**DEPARTMENT OF TRANSPORTATION  
STATE OF GEORGIA**

**FILE:** EDS-84(26), HPPN-EDS-84(27) & NHN-007-03(28) **OFFICE:** Eng. Services  
Ware County  
P.I. Nos.: 522770, 522780 & 522775  
S.R. 38/U.S. 84 Widening/Reconstruction and Bridge Replacement

**SUBJECT: IMPLEMENTATION OF VALUE ENGINEERING STUDY ALTERNATIVES**

# VALUE ENGINEERING STUDY REPORT RESPONSES

VE Comment A-11  
Layout comparison

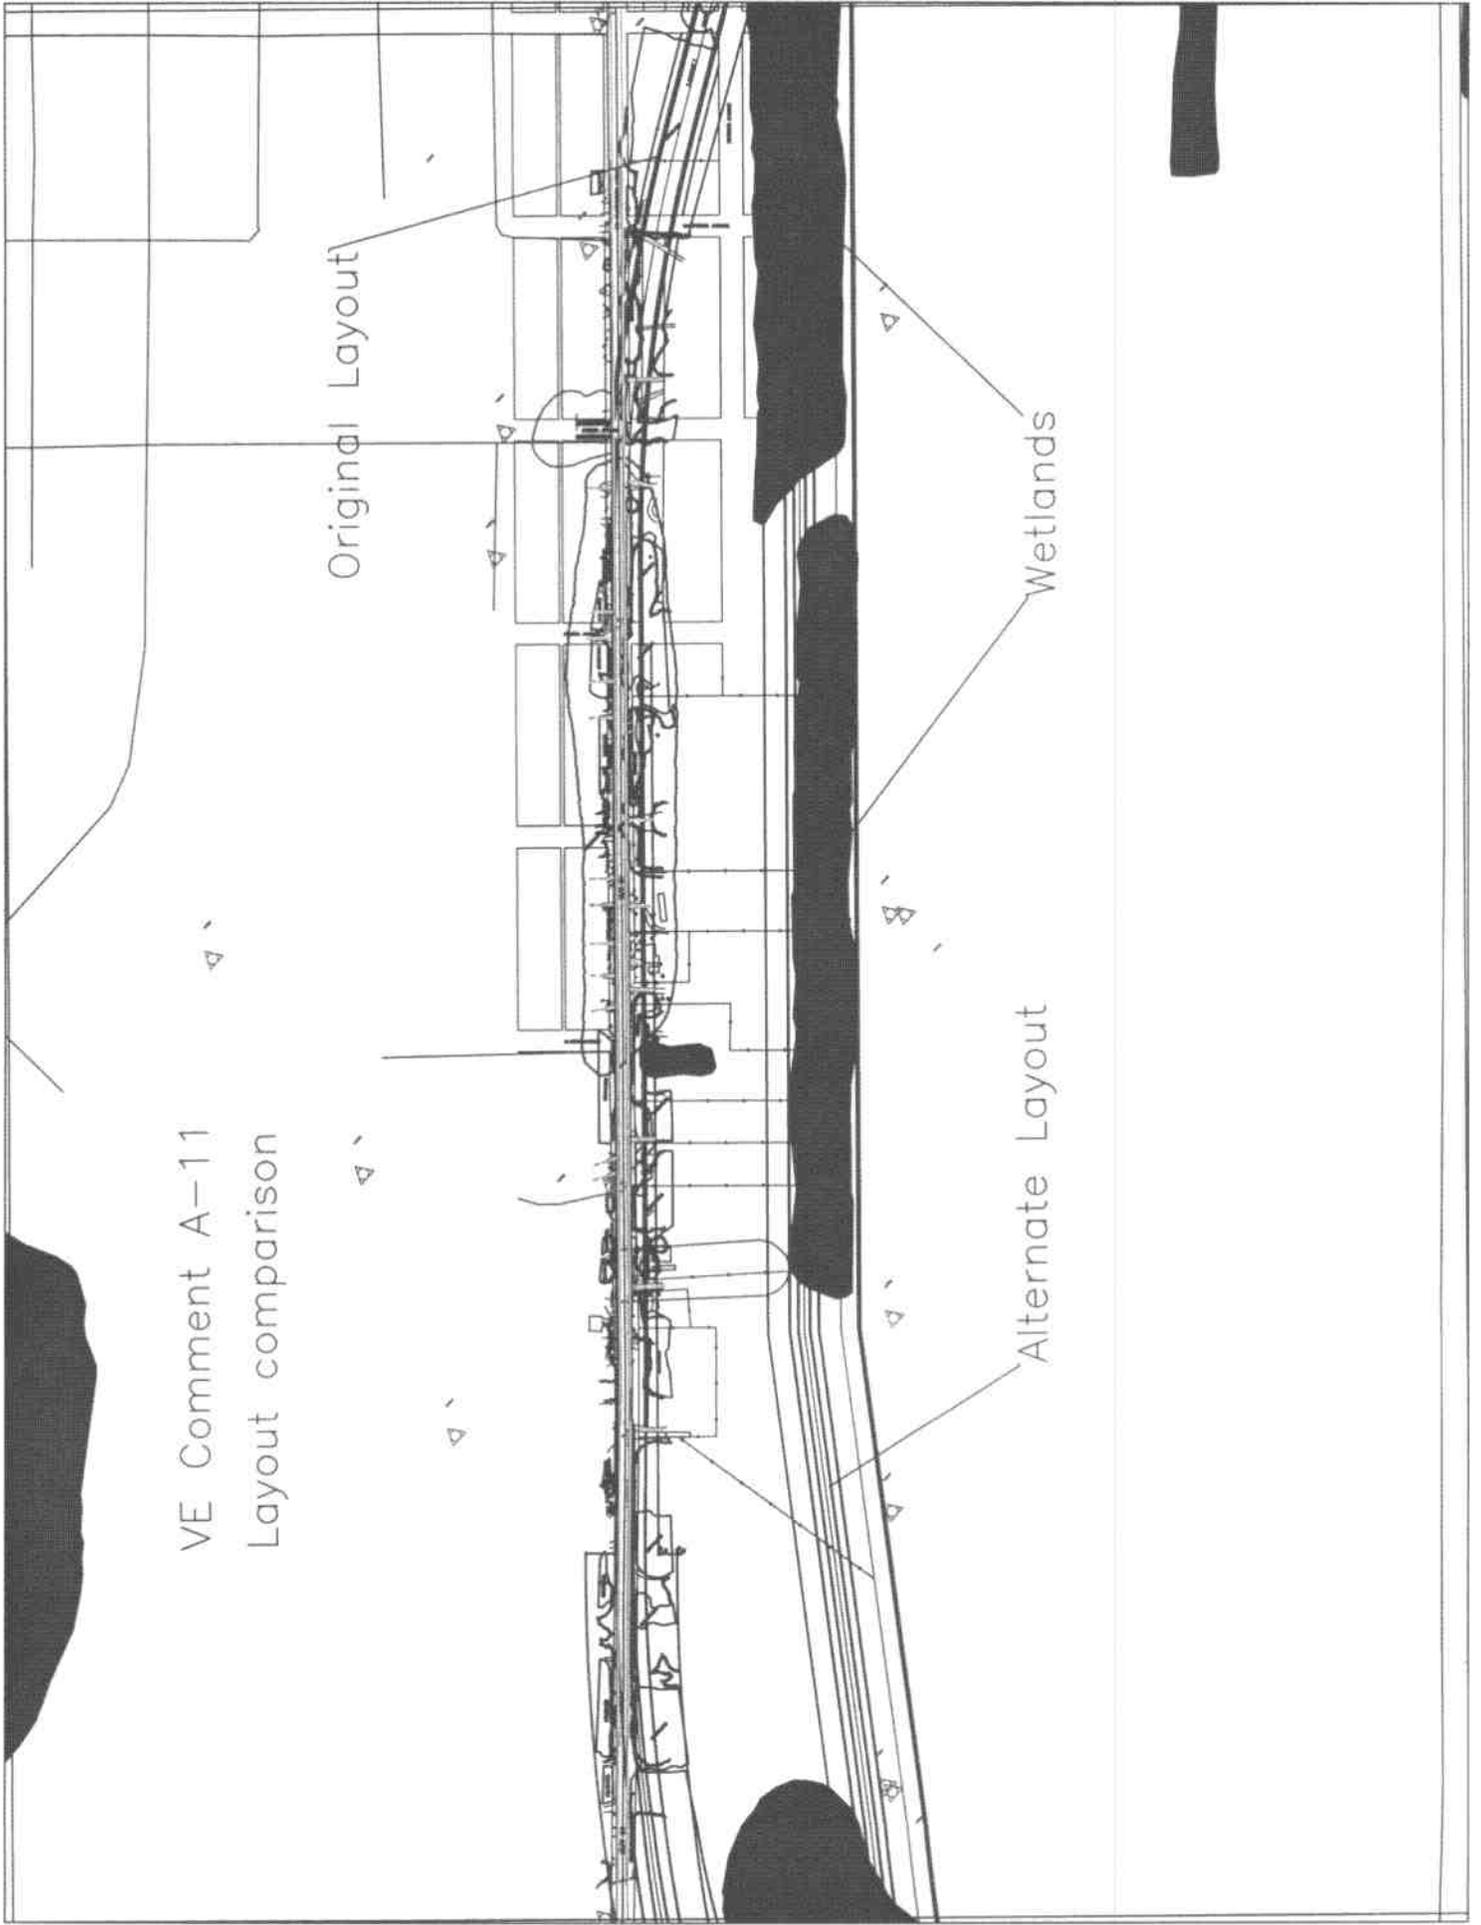
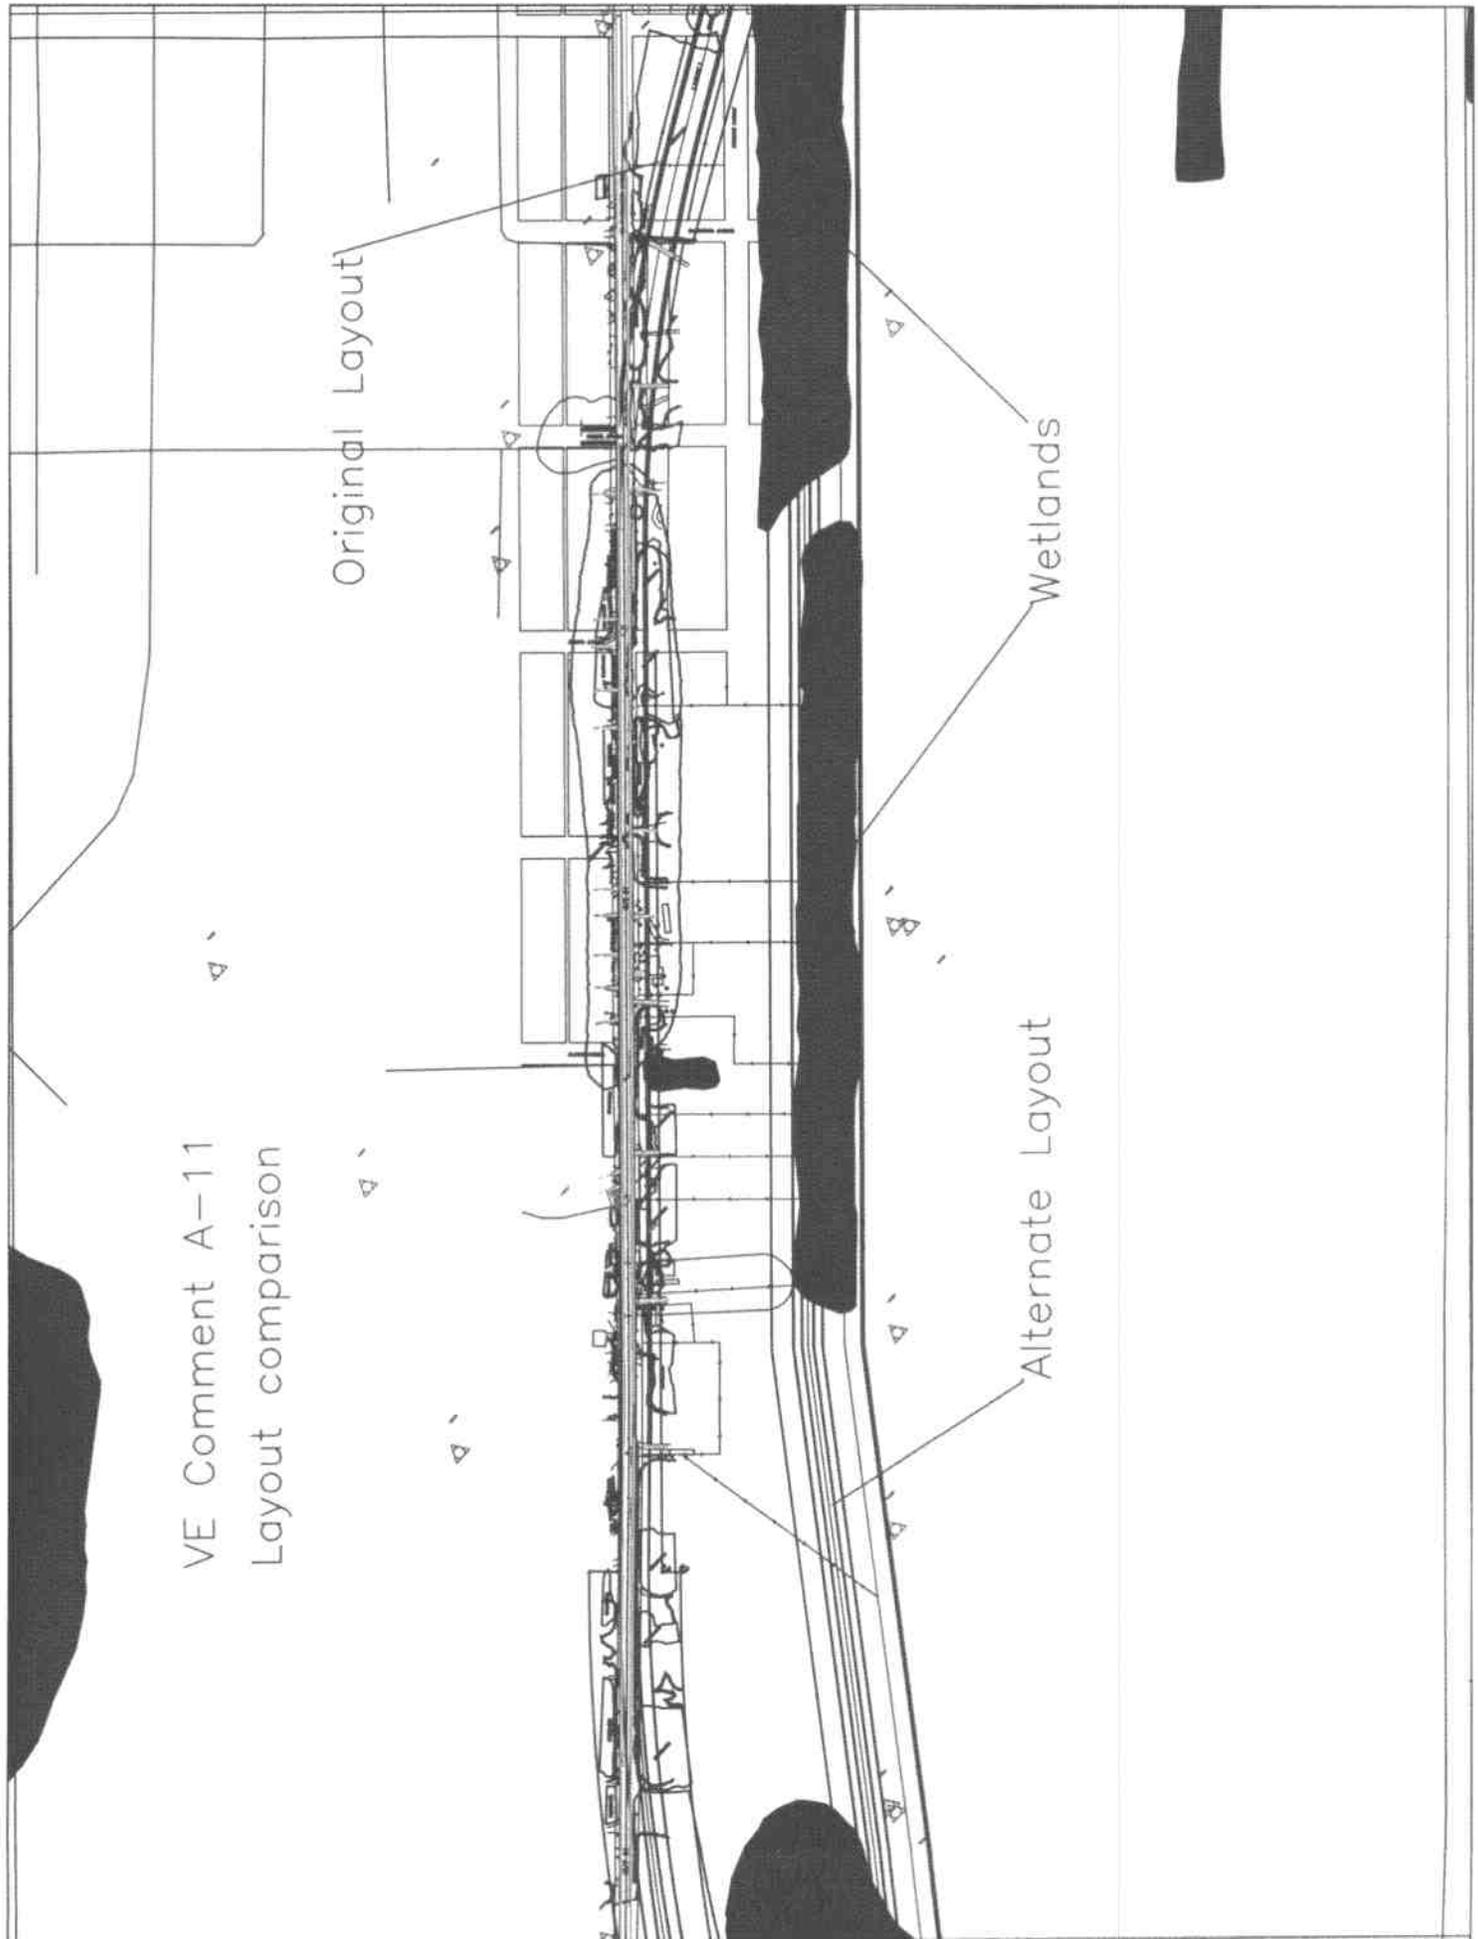
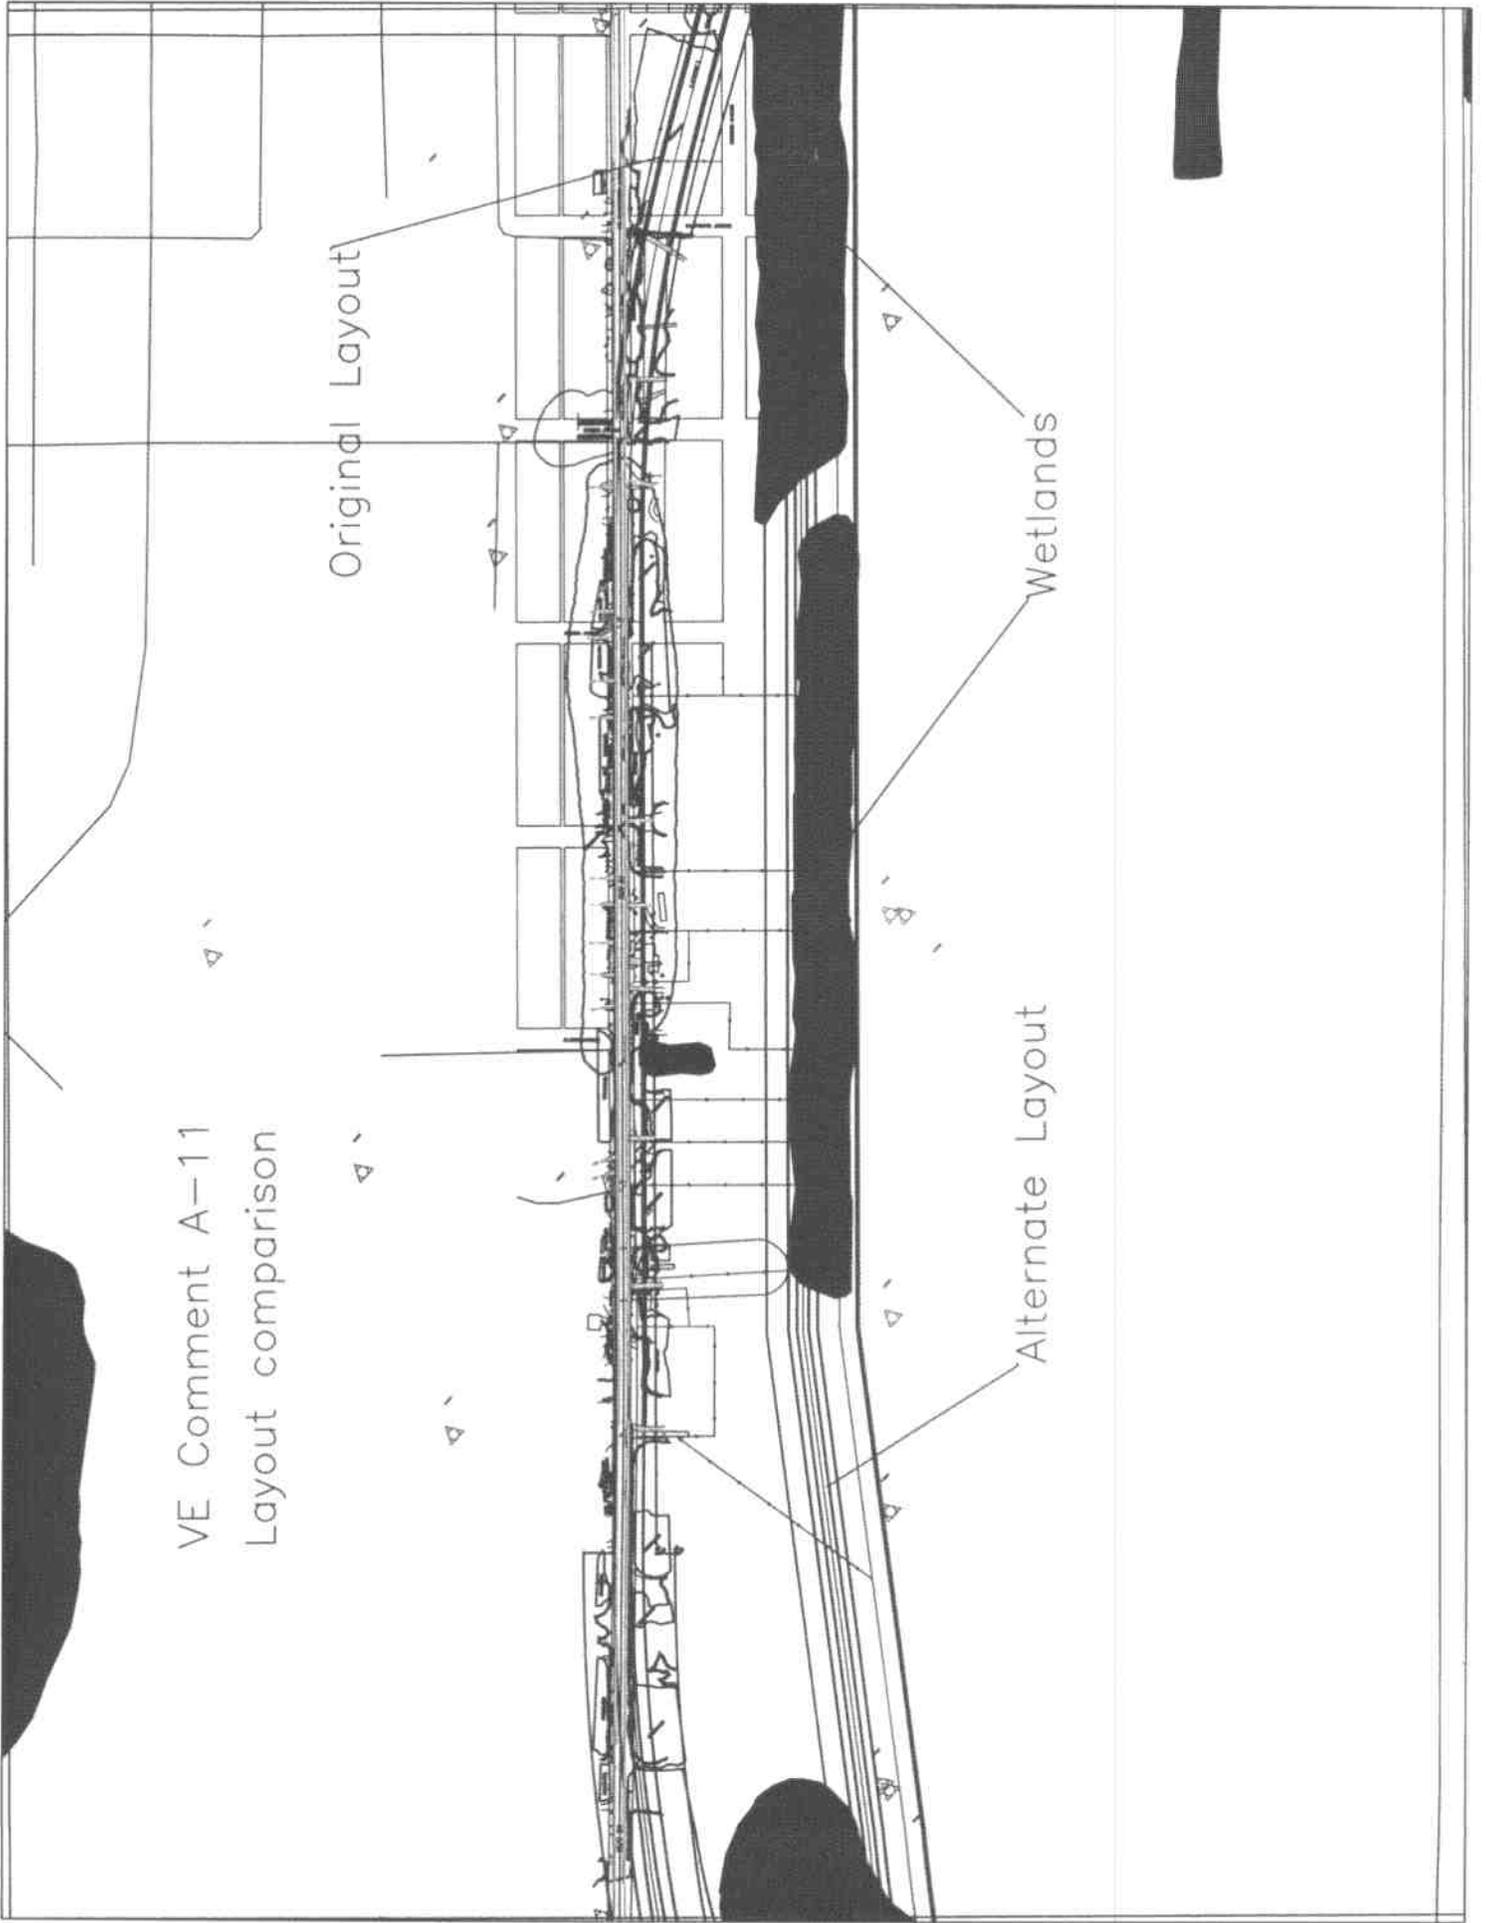
- A-10 Move alignment closer to railroad from STA 114+00 to 162+50 2  
**The alignment will be shifted to parallel the railroad right-of-way.**
- A-11 New alignment along railroad right-of-way from 16<sup>th</sup> St to New Mexico 2

**There are two existing ponds along the railroad right-of-way that will create enormous environmental and wetland impacts if this suggestion is implemented making this an impractical alternative. (See attachment A-11)**
